VISUAL SITE INSPECTION REPORT – 2019

HOOSIER ENERGY
RURAL ELECTRIC COOPERATIVE, INC.
MEROM GENERATING STATION
AREA 3 RESTRICTED WASTE LANDFILL
MEROM, INDIANA

ATC PROJECT NO. 170LF00788

December 16, 2019

Drn. By:	JG	Ckd. By:	MT	App'd By:	DS	Ckd. Date:	12/2019
Project Number:	17OLF00629	Drawing File:	SEE LOWER LEFT				
OBSERVATION LOCATION PLAN AREA 3 RESTRICTED WASTE LANDFILL 2019 INSPECTION HOOSIER ENERGY MEROM GENERATING STATION							
Date: 12/19 Scale: AS SHOWN Figure: 2

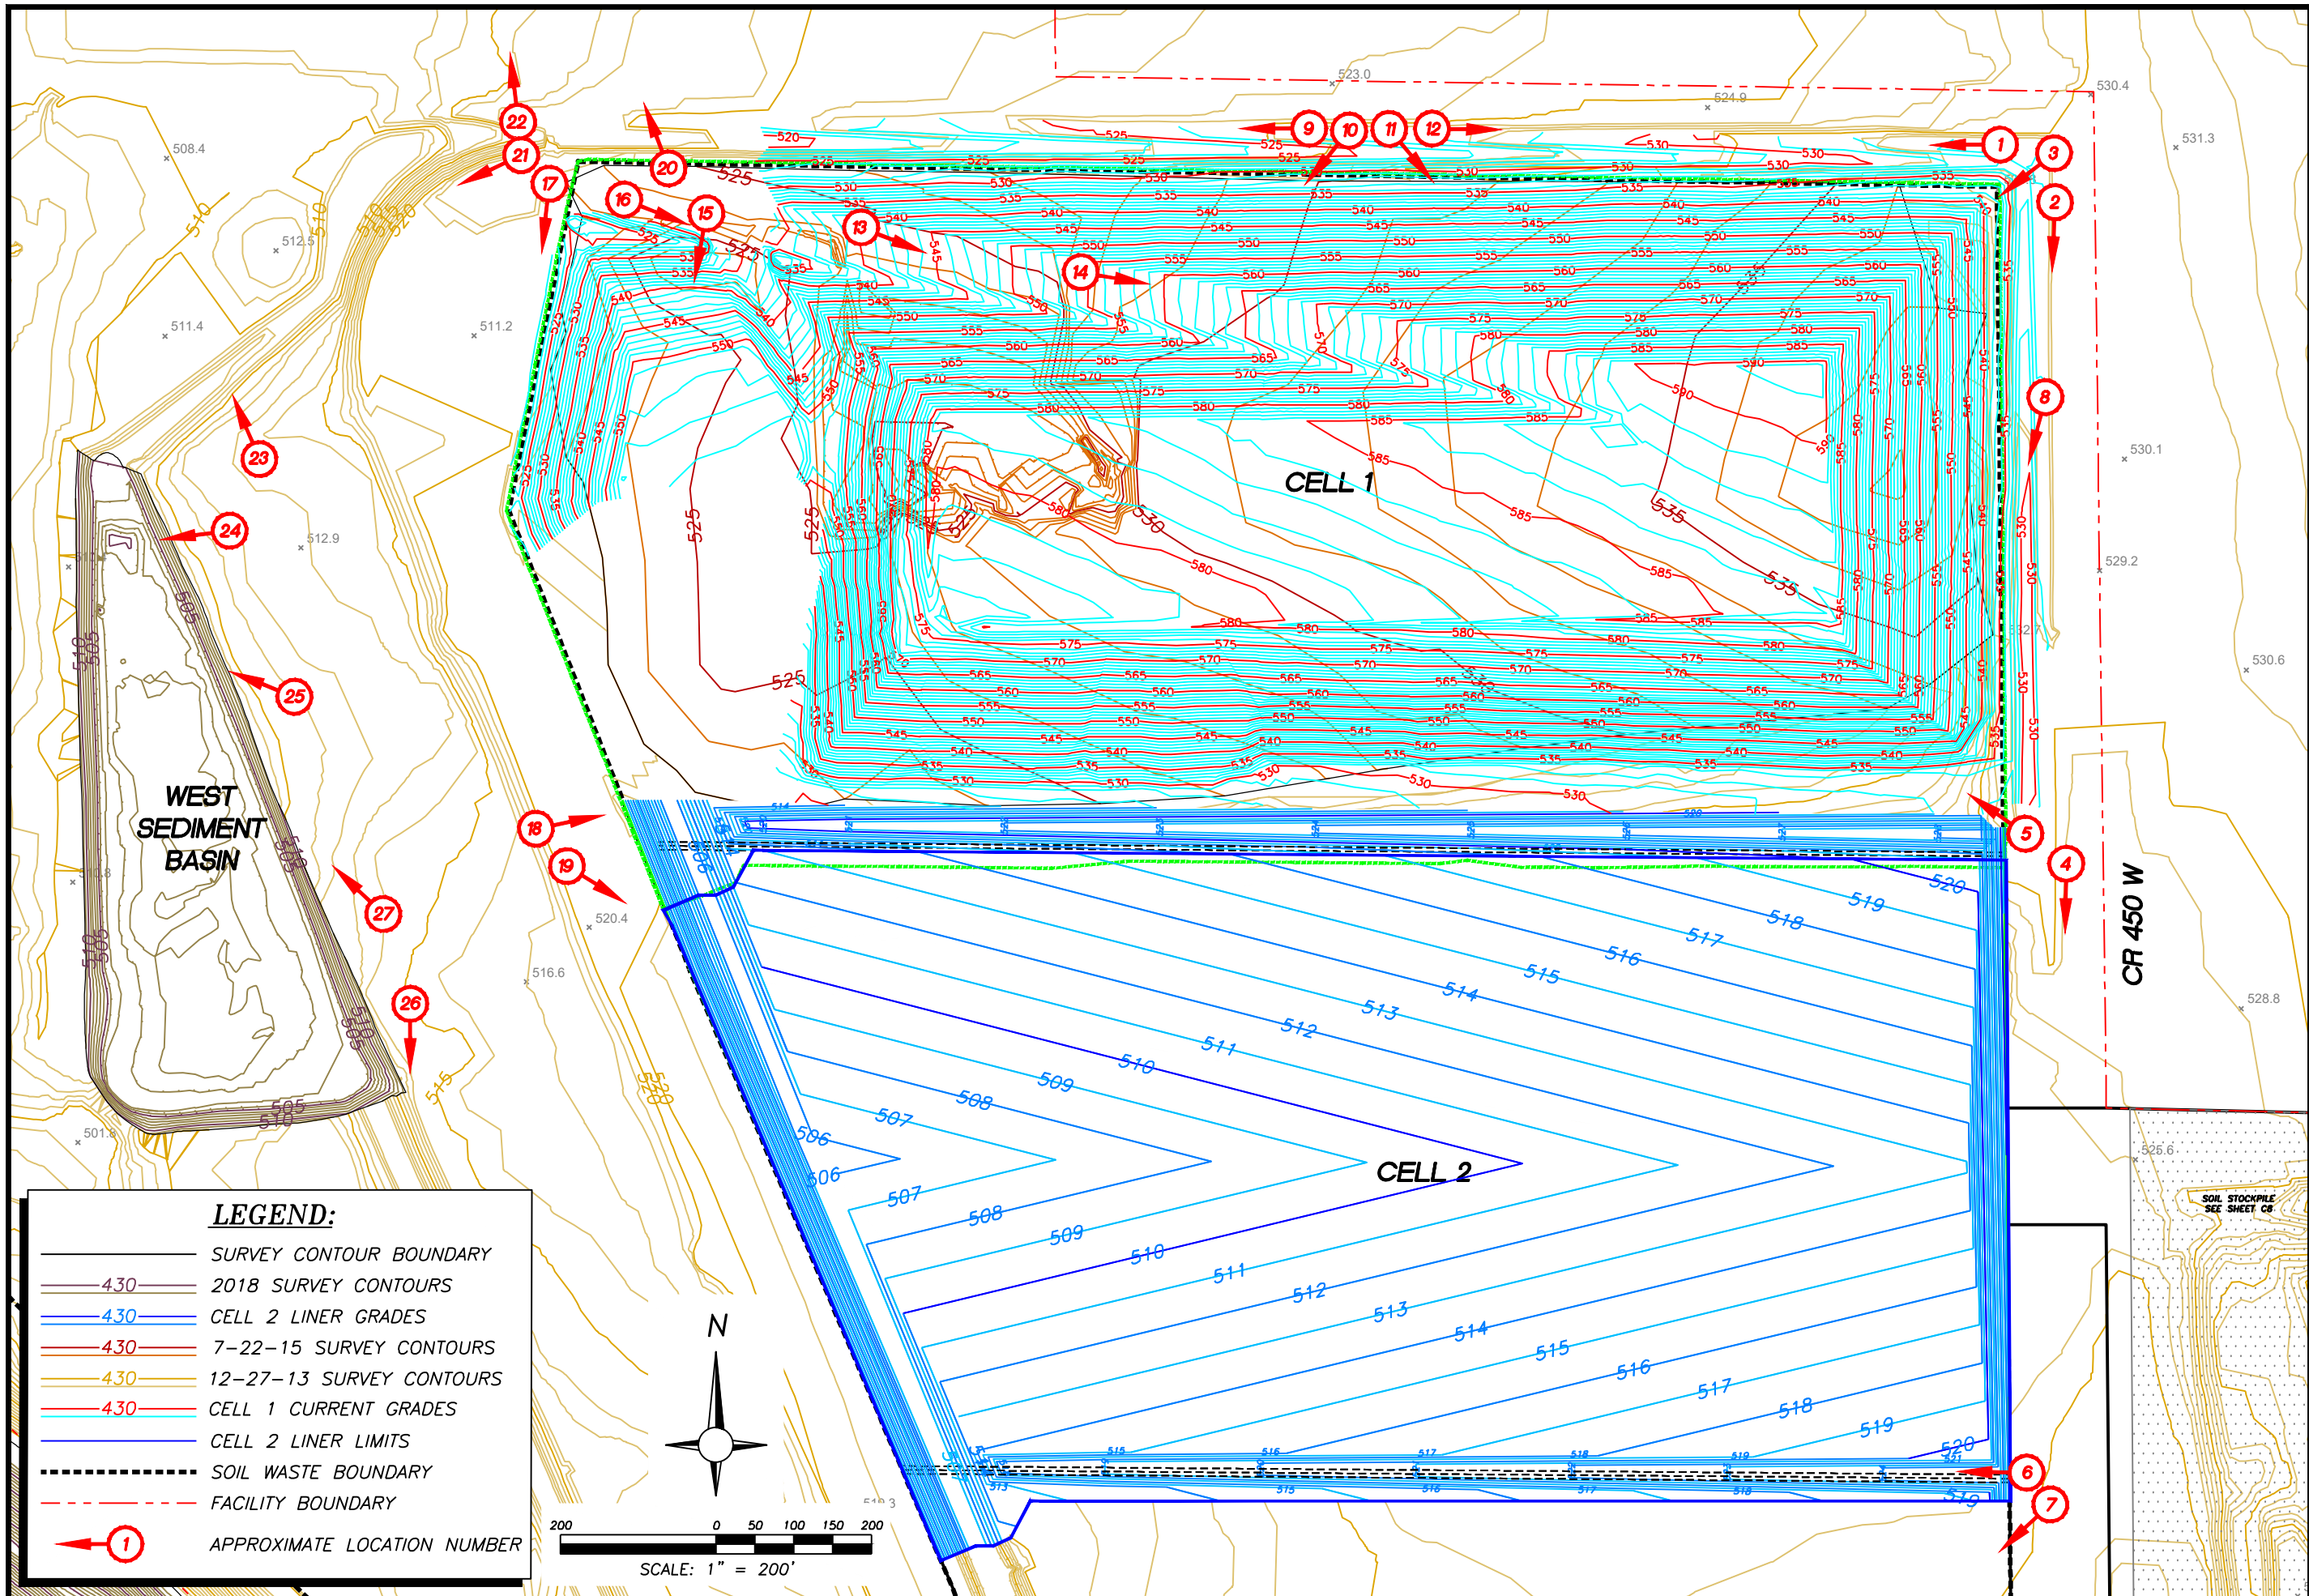
- 2) At Location 4 near the southeast corner of Cell 1 the inspection noted that vehicle ruts, erosion, and sediment deposits in the perimeter channel that were noted from the 2018 inspection have been repaired and vegetation has been well established.

- 3) At Location 5 near the southeast corner of Cell 1 the inspection noted that the interior south slope of Cell 1 appears to be well graded and has received an interim vegetated cover.

- 4) At Location 6 near the southeast corner of Cell 2 the inspection noted that contact stormwater runoff is contained within Cell 2

- 5) At Location 7 near the southeast corner of Cell 2 the inspection noted that the future Cell 3 area has well established vegetation.

- 6) As noted at Location 8 on the east side of Cell 1 the inspection identified erosion at the toe of the slope above the perimeter ditch.

- 7) At Locations 13 and 14 on the north side of Cell 1 the inspection noted erosion along the road to the top of Cell 1.

- 8) At Location 15 at the northwest corner of Cell 1 the inspection noted erosion from the road into the drainage channel.

- 9) At Location 16 at the northwest corner of Cell 1 the inspection noted that erosion in the road into the drainage channel.

- 10) At Locations 17 near the northwest corner of Cell 1, the inspection noted that the sediment levels in the concrete lined pond are maintained at acceptable levels.

- 11) At Location 18 near the northwest corner of Cell 2 the inspection noted a patch of bare soil above a drainage culvert that could be susceptible to erosion.

- 12) At Locations 19 along the west side of Cell 2, the inspection noted that the outside slope of the perimeter berm above the concrete ditch and the outside slope of the Cell 2 south perimeter berm has established vegetation. Additionally, the 2018 inspection noted sediment deposits in the concrete ditch that have been removed.

- 1) At Location 20 in the stormwater channel northwest of Cell 1 the 2018 inspection noted sparse vegetation at the riprap interface. The 2019 inspection noted well established vegetation.

- 2) At Locations 21 and 22 in the stormwater channel northwest of Cell 1 the inspection noted erosion at the edge of the riprap.

- 3) At Location 23 in the stormwater channel west of Cell 1, the inspection noted heavy equipment damage adjacent to the riprap lined channel.

- 4) At Location 24 and 25 on the east slope of the West Sediment Basin west of Cell 1 the inspection noted erosion at the crest of the pond.

- 5) At Location 26 on the east slope of the West Sediment Basin west of Cell 1 the inspection noted sediment deposition in the southeast corner of the pond at the inlet of the concrete channel.

- 6) At Location 27 on the east slope of the West Sediment Basin west of Cell 1 the inspection noted that the pond is generally in good condition and maintaining adequate freeboard.

Recommendation: Fill the erosion rill and reseed as needed to prevent further erosion.

Recommendation: Fill the erosion and reseed as needed to prevent further erosion. Consider adding more berms to direct stormwater into the drainage ditch.

Recommendation: Fill the erosion and add armoring to prevent further erosion.

Recommendation: Fill the erosion and add armoring to prevent further erosion.

Recommendation: Continue routine sediment removal.

Recommendation: Reseed the area as needed to establish vegetation.

Recommendation: Continue to maintain the established vegetation and continue regular maintenance of the concrete channel.

Recommendation: Repair the erosion damage and utilize appropriately sized riprap for the expected stormwater flows.

Recommendation: Reseed the area as necessary to reestablish vegetation.

Recommendation: Regrade the area as necessary to restore the drainage into the pond and reseed to reestablish vegetation.

Recommendation: Remove sediment deposits from the channel and the pond on a regular basis.
